State of Utah
Department of Commerce
Division of Public Utilities

Date: October 4, 2010

Re: PacifiCorp's 2008 Integrated Resource Plan Update, Docket No. 09-2035-01, Geothermal Resource Study

Figure 1: Black & Veatch Analytical Model (Roosevelt, Low Scenario)

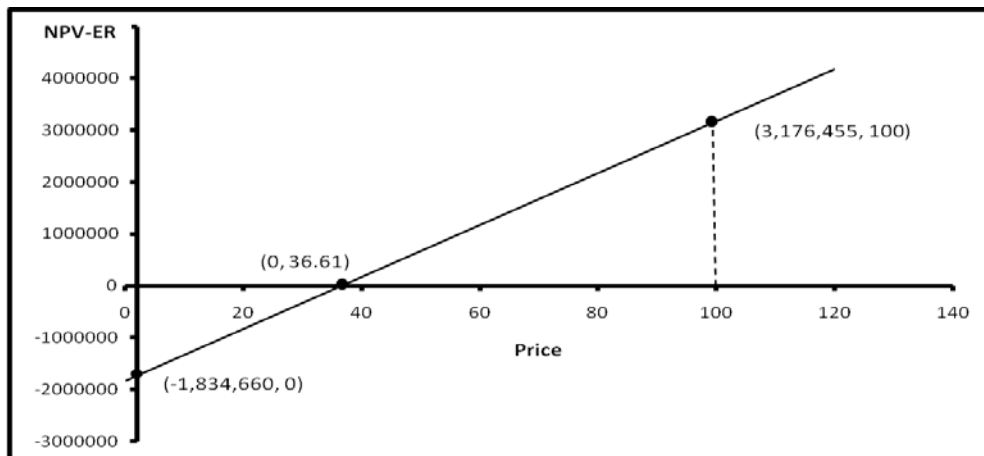
example, at \$100/MWh yields a NPV-ER equal to approximately \$3.2 million.¹² If the first year price is set at \$0/MWh, the NPV-ER is approximately -\$1.8 million. The breakeven price is then found as the solution to the line connecting these two points. In this case, the first year breakeven price is \$36.61/MWh. This relationship is depicted in Figure 1 below.

This linearity assumption, which is not identified in BVG’s geothermal report, appears to place peculiar restrictions on the output the model. For example, the total annual megawatt hours do not affect the final LCOE. This is because percent changing the capacity of the project changes both the revenues and the expenses by the same percentage and, therefore, the LCOE is unchanged. Similarly, increasing the O&M costs in the Roosevelt model from \$21 per MWh to \$26.25 per MWh, approximately 25%, increases the LCOE from \$45.60 per MWh to \$52.11 per MWh, approximately 14% or approximately half of the increase in the O&M cost. Other percentage changes in the O&M cost yield similar changes in the LCOE.
